From:	Robert Wales <rawales@gmail.com>
Sent on:	Friday, February 21, 2020 3:10:15 PM
To:	Dermody, Bill (CI-StPaul) <bill.dermody@ci.stpaul.mn.us>
Subject:	RM Zoning Study Comments

Re: Parking and Setback Requirements – Written Testimony, RM Zoning Study

RE: Feedback on Proposed Changes to RM Zoning

6 Oakley Avenue

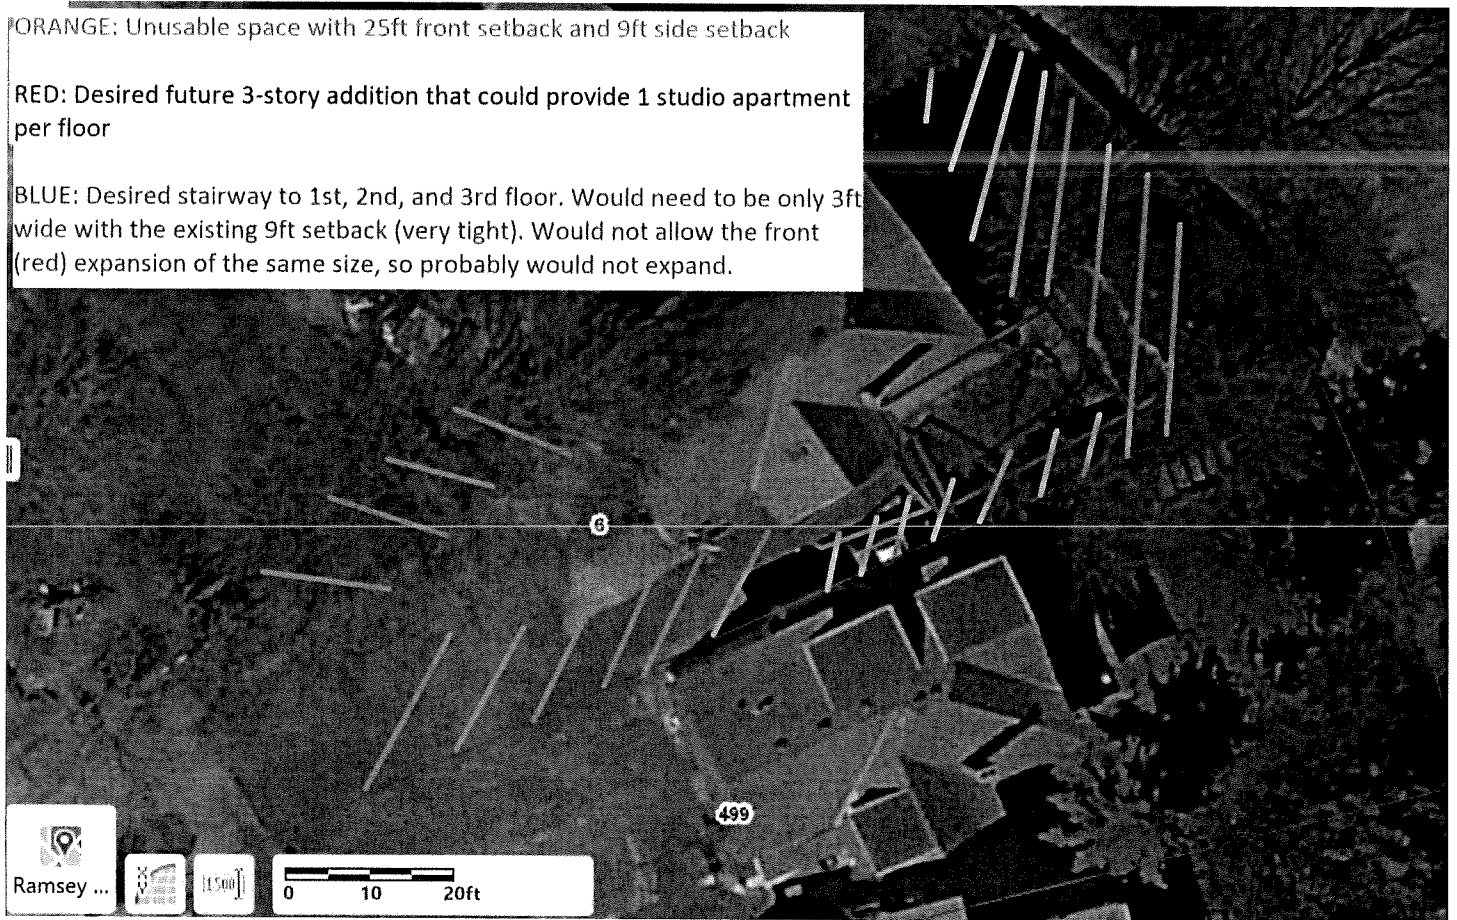
ORANGE: Unusable space with 25ft front setback and 9ft side setback

RED: Desired future 3-story addition that could provide 1 studio apartment per floor

BLUE: Desired stairway to 1st, 2nd, and 3rd floor. Would need to be only 3ft wide with the existing 9ft setback (very tight). Would not allow the front (red) expansion of the same size, so probably would not expand.

I was hoping to be able to use some of my front and side yard to expand the building to provide more housing. A reduced front setback would more easily allow me to add a 2nd and 3rd floor deck off the front of the apartments that overlook Iris park directly ahead (which would be an attractive feature).

If a 9ft side yard setback remains in place, the most I could expand in the red outline is about 11ft to the side and 10ft to the front because I would need additional space in the blue area for a 6ft wide (minimum) stairway. This would mean that the addition to the building would not accommodate any additional units and not be worth the investment.

1612 Van Buren Avenue

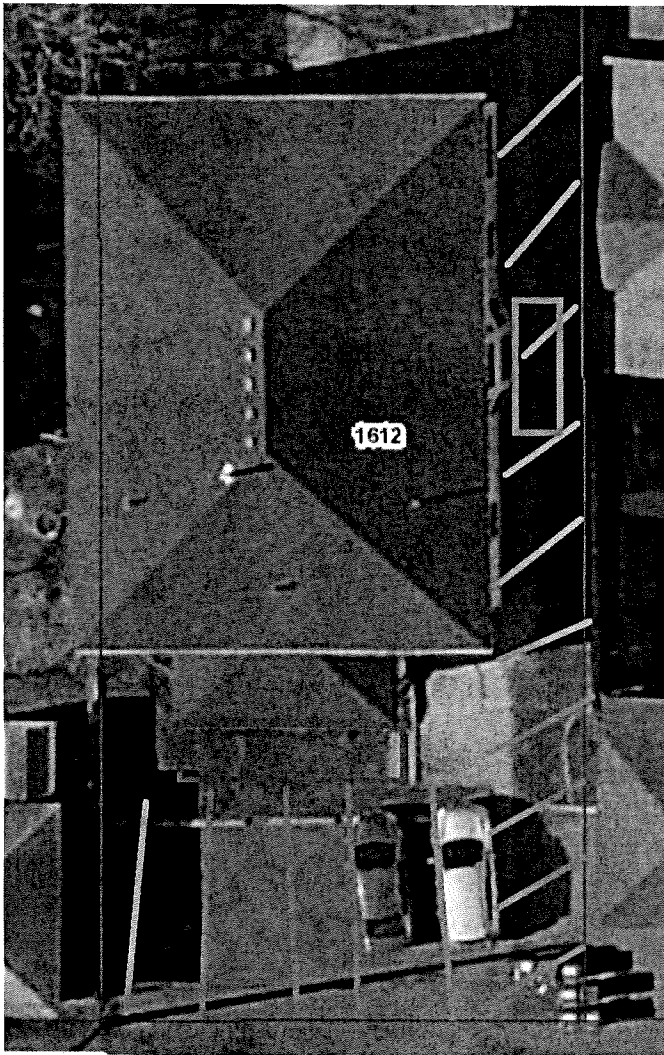
The orange lines show how the 9ft side and rear-yard setback eliminate the possibility expansion.

The blue boxes indicate where I'd like the option of building steps/decks to the 1st and 2nd floors to accommodate additional apartments. I have no option on the side yard, and have a very tight fit on the rear and would likely need to request a variance of a few feet unless I want to try to create a crazy spiraling staircase in the space off to the right and a narrow walkway along the back, which would be ugly.

Exhibit: Common Examples of Existing Structures Zoned RM with Non-Conforming Side Yard Setbacks

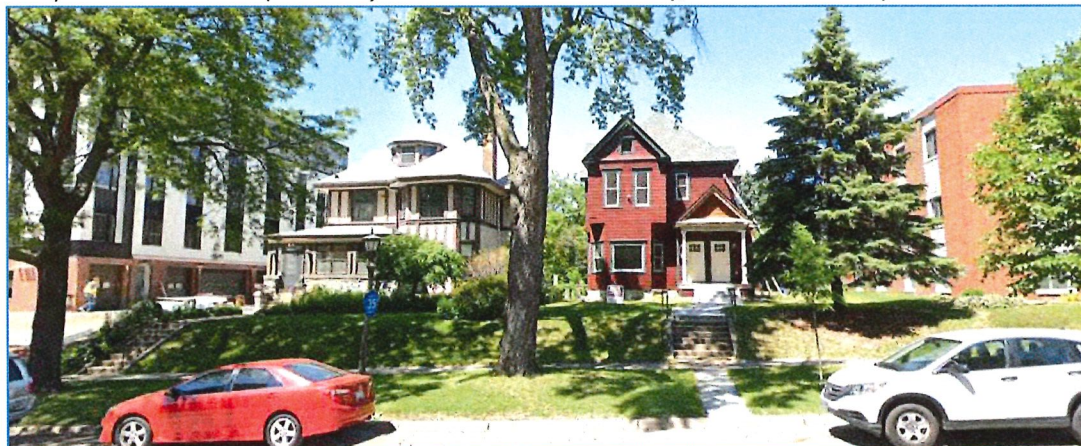
1787 Grand Ave – 18 units built in 1960 (~3' setbacks on either side)

1848 St. Clair Ave – 14 units built in 1938 (~5' side yard on west side) & 1854 St. Clair Ave – 10 units built in 1935 (~4' on east side and ~5' on west side)

1969 Marshall Ave – single family built in 1889 (3' setback on east side and 6' on west side) & 1963 Marshall Ave – duplex built in 1900 (~7' side yard setback on west side), which would require a variance to add a basement unit

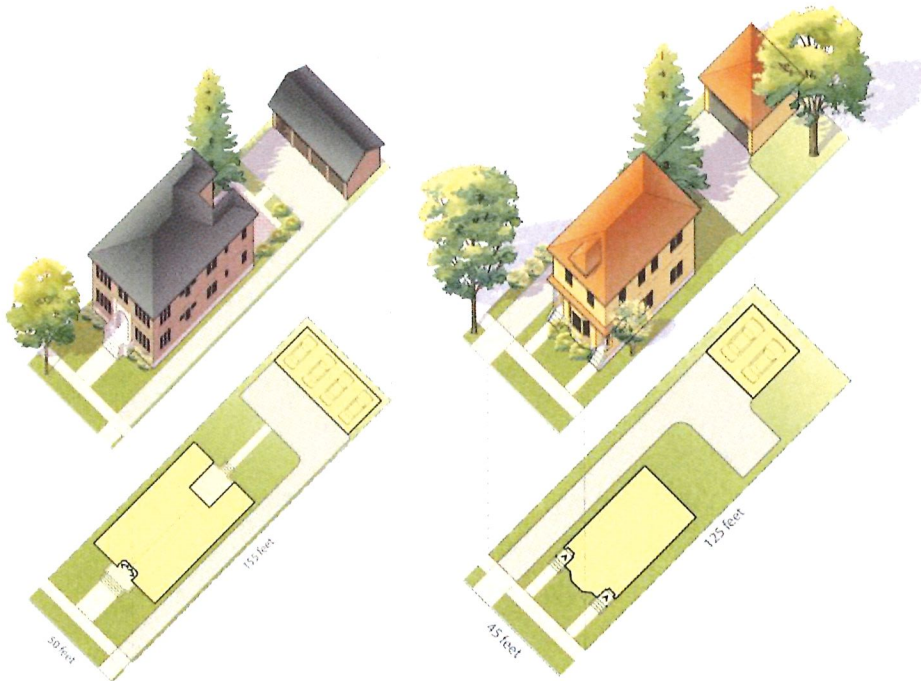
Summit Hill Association supports the elimination of Existing Footnote (c), “No multiple-family dwelling shall be built, nor shall additional dwelling units be added to an existing building to create three (3) or more dwelling units, on a lot that is less than nine thousand (9,000) square feet in area.”

Allowing the conversion of large houses to duplex or triplexes is a viable way to increase density in an incremental manner, and increase the economic viability of existing structures. The 9,000 SF is arbitrary and creates an undue burden on development and expansion.

Furthermore, smaller buildings are less likely to require expensive systems such as elevators and sprinklers. Increasing the number of lots in which triplexes are permitted should allow more economical development of properties with increased density and more variety of housing types.

D.6 SPECIFIC COMMENT OF OPPOSITION: ELIMINATION OF THE ALLEY FOOTNOTE

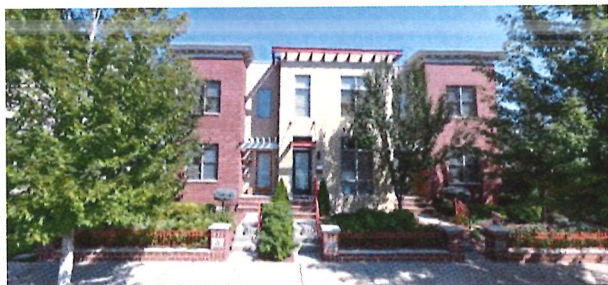
Summit Hill Association opposes the elimination of Existing Footnote (b), “In calculating the area of a lot that adjoins a dedicated public alley, for the purpose of applying lot area and density requirements, one-half the width of such alley adjoining the lot shall be considered as part of the lot.”

The intended purpose of eliminating this footnote is to decrease redundancy, *since the “alley bonus” is elsewhere in the zoning code, and its appearance in Table 66 is redundant. We would like to underscore our support for the “alley bonus.” Retaining it as a footnote, while redundant, increases the awareness of accessibility of this information. In a document as complex and dense as the zoning code, we feel that redundancy is less of a problem than not being able to locate information. Therefore, we suggest leaving the alley footnote in this section.*

*The alley bonus is important. Without it, the result would be to essentially “shrink” existing lots with alleys (for zoning purposes). For example, for a typical 40 foot lot with a typical 20 foot alley, the reduction (from current zoning) would be 400 SF. Approximately two-thirds of properties in St Paul have alleys, **the elimination of this provision will decrease density and decrease lot coverage, compared to what is allowed presently; and result in an increase in variance applications.***
